# One Earth Solar Farm

**Written Summary of Applicant's Oral Submissions at the Issue Specific Hearing 3 (ISH3)**

**Document Reference : EN010159/9.37**

Revision 1

TITLE  
Works area 3 indicative section

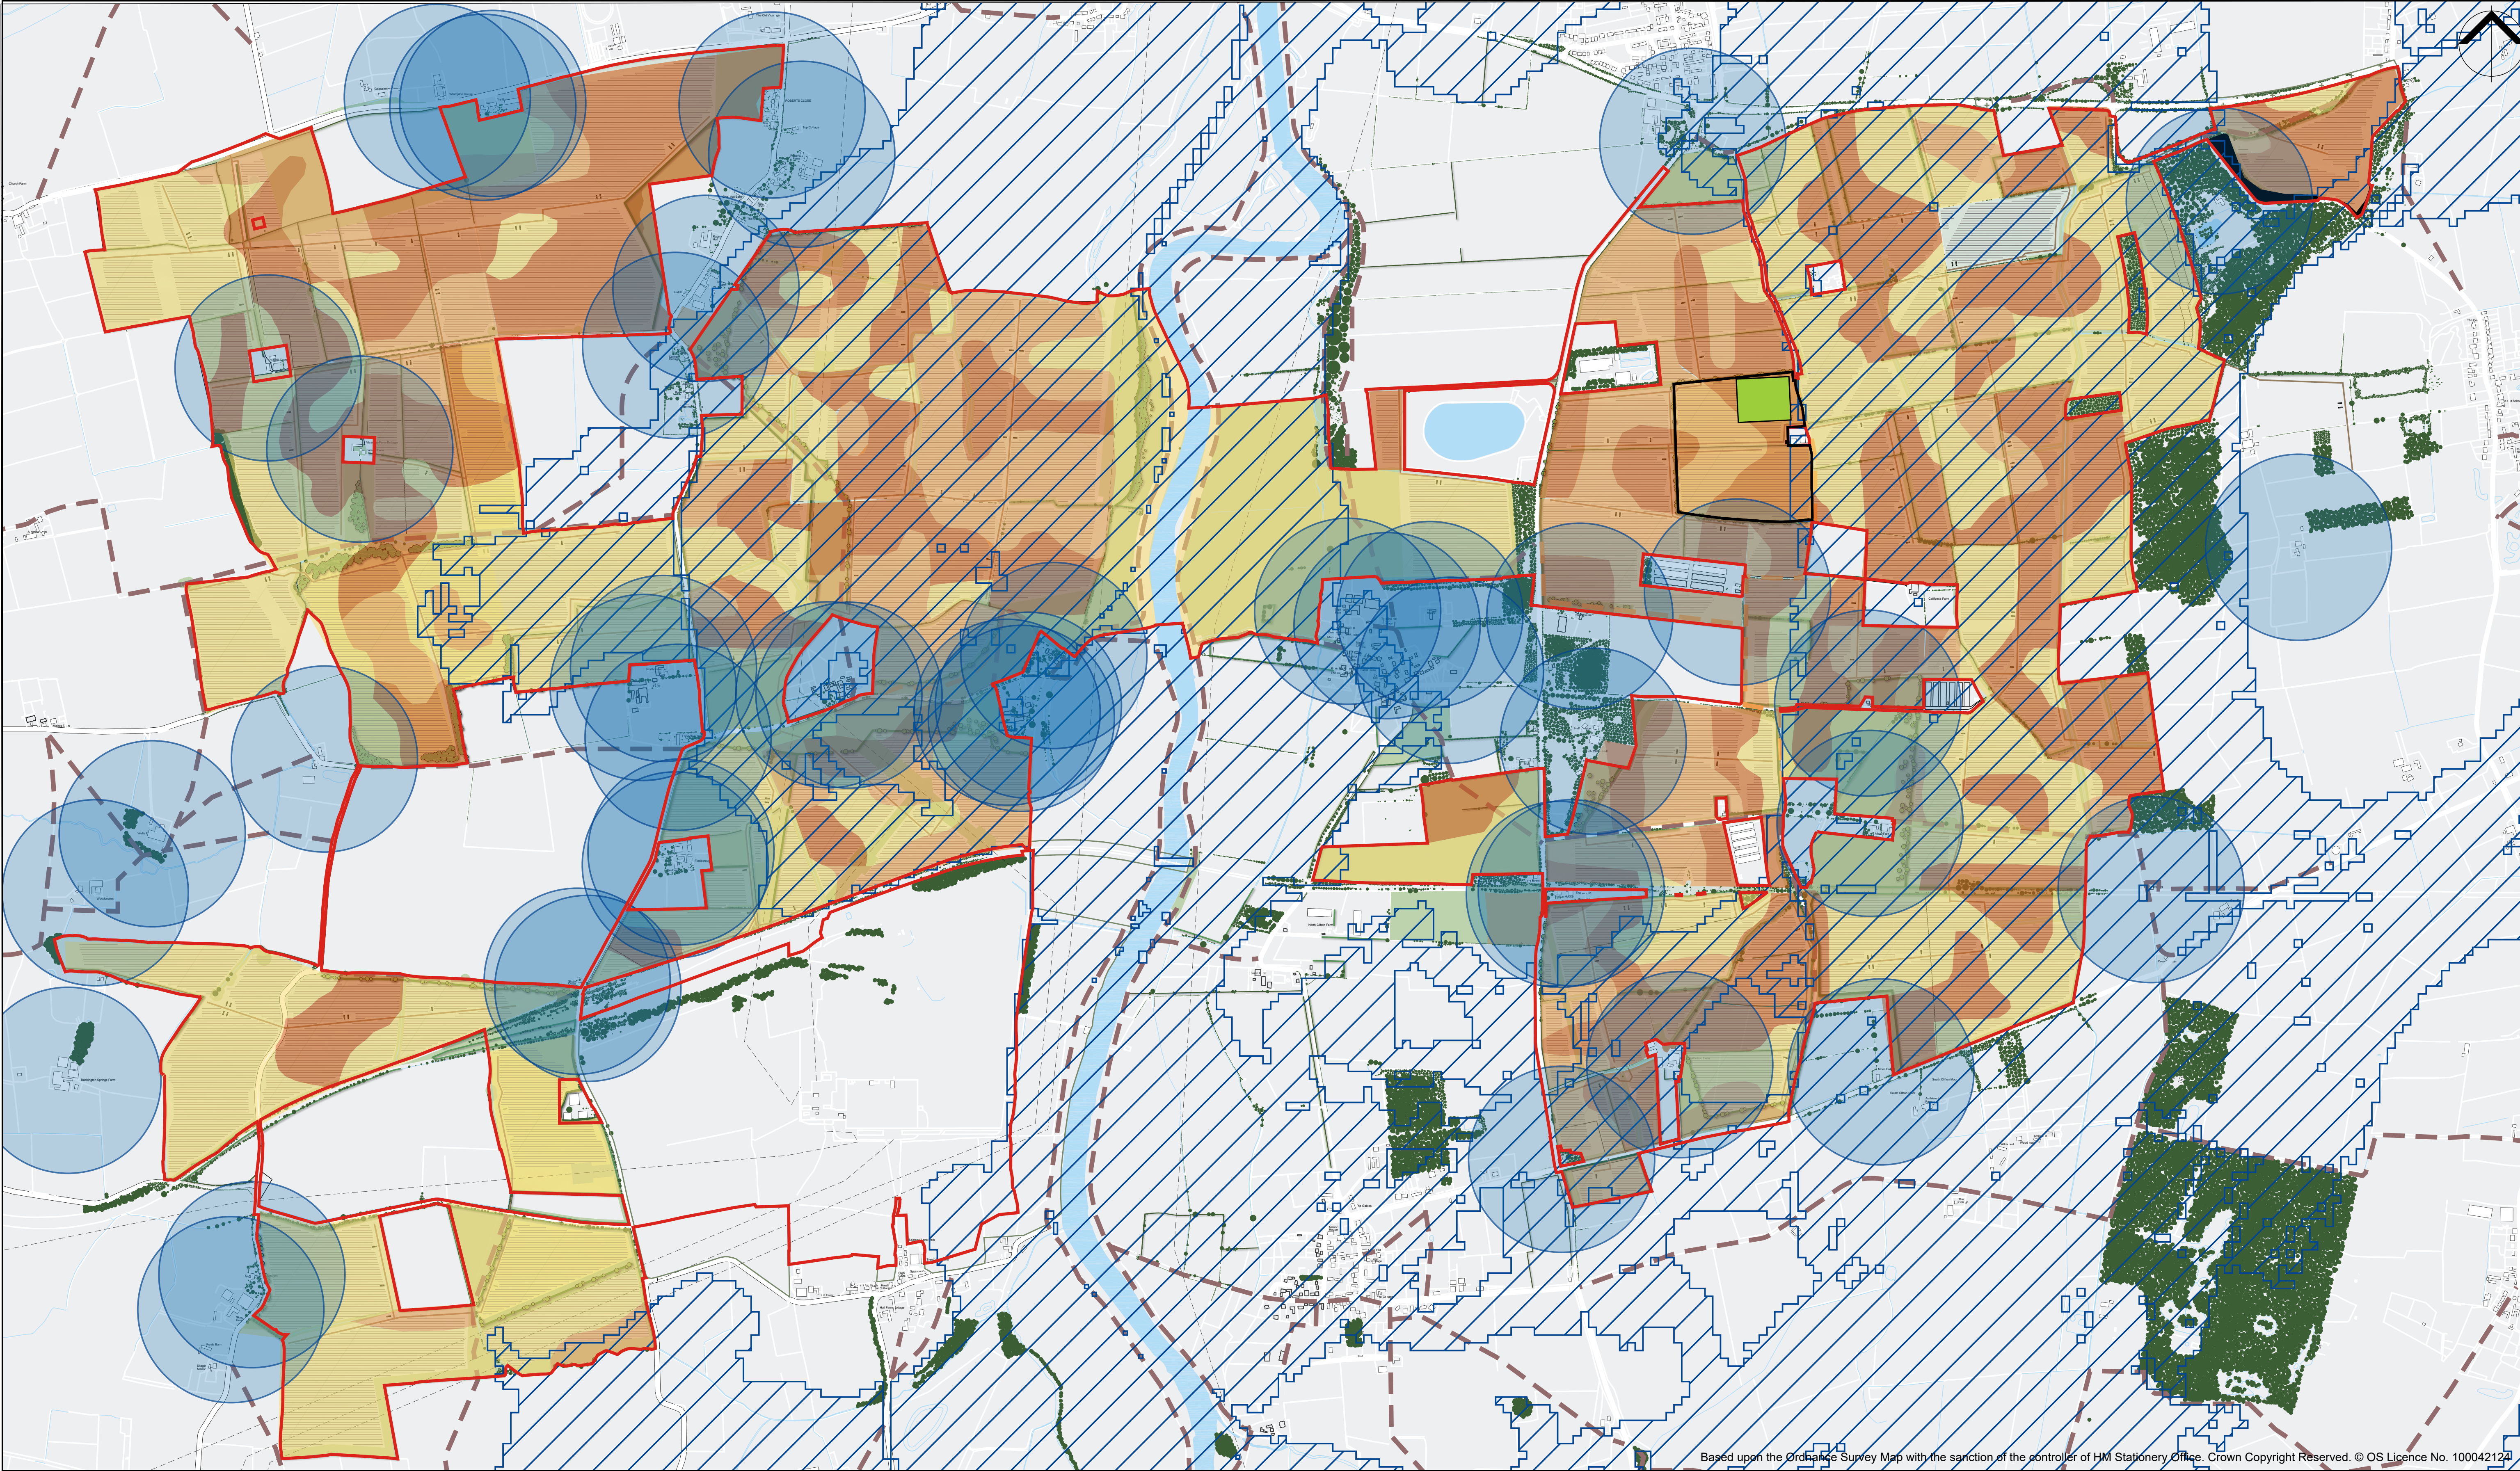
7	<p><b>Landscape and Visual Amenity</b></p> <p>(i) The ExA will seek views from the applicant and the councils upon the approach to minimising the visual effect of the proposed development and the suitability of the assessment and the application of the mitigation hierarchy as expected from NPS EN-1 paragraph 4.1.5.</p> <p>(ii) The ExA will explore the suitability of the siting of the eastern substation and the drafting of current parameters</p> <p>(iii) The ExA will explore the mitigation proposed along the A1133 and A57 and how this achieves a sustainable development</p>	<p>The ExA sought views from the Applicant and LPAs on the approach taken to minimise the visual effects of the proposed development, the suitability of the assessment, and the application of the mitigation hierarchy as required by NPS EN-1 paragraph 4.1.5.</p> <p>Mr. Sam Griffiths confirmed on behalf of the Applicant that significant progress has been made in resolving matters, as reflected in the most recent SoCG with LCC, NSDC, BDC, and NCC. The majority of items are now agreed, with only two points remaining where definitive positions have not yet been reached. More issues remain outstanding with WLDC, but following further meetings, the Applicant anticipates reaching a firm conclusion shortly.</p> <p>Mr. S. Griffiths stated that impacts on landscape and visual receptors have been agreed with all councils except WLDC.</p> <p>The ExA sought an update on whether WLDC had addressed its outstanding concerns regarding the siting of the eastern substation and the drafting of design parameters.</p> <p>WLDC confirmed that discussions with the Applicant are ongoing. The Applicant has provided further information, which WLDC is reviewing, and progress is being made through the SoCG.</p> <p>The Applicant made no submissions on this agenda item.</p> <p>Mr. S. Griffiths presented information during the hearing, referencing the Eastern Substation Siting Constraints Plan (to be submitted at Deadline 5). Key points included:</p>

#	Agenda item	Written summary of Applicant's oral submissions
	through construction, subsequent operation and decommissioning.	<ul style="list-style-type: none"> <li>The substation is sited outside the flood event extent and complies with project-specific distances: at least 300m from residential dwellings and 100m from PRow.</li> <li>The Outline Design Parameters [REP4-012] secure the substation footprint within Work No. 3, as shown by the green box on the plan. Diagonal blue lines indicate flood event extent, and blue circles represent 300m residential offsets.</li> <li>The discussion with WLDC concerns the precise location within the defined black box. Alternative positions were considered but would introduce other issues, such as proximity to dwellings.</li> <li>Eastern Substation Cross Section: This document shows that land levels gradually fall away from the A1133. The Applicant seeks flexibility in siting and has assessed visual impacts, concluding that moving the substation further downhill would have negligible effect on thresholds for visual impact in LVIA terms.</li> <li>The BESS is also proposed in this area. Restricting flexibility would constrain detailed design, which will be addressed at the detailed design stage with input from relevant authorities.</li> </ul>

**Post hearing note:** The following supporting documents have been provided at **Appendix B** to this Written Summary for Deadline 5:

- The Eastern Substation Siting Constraints Plan
- The Eastern Substation Cross Section
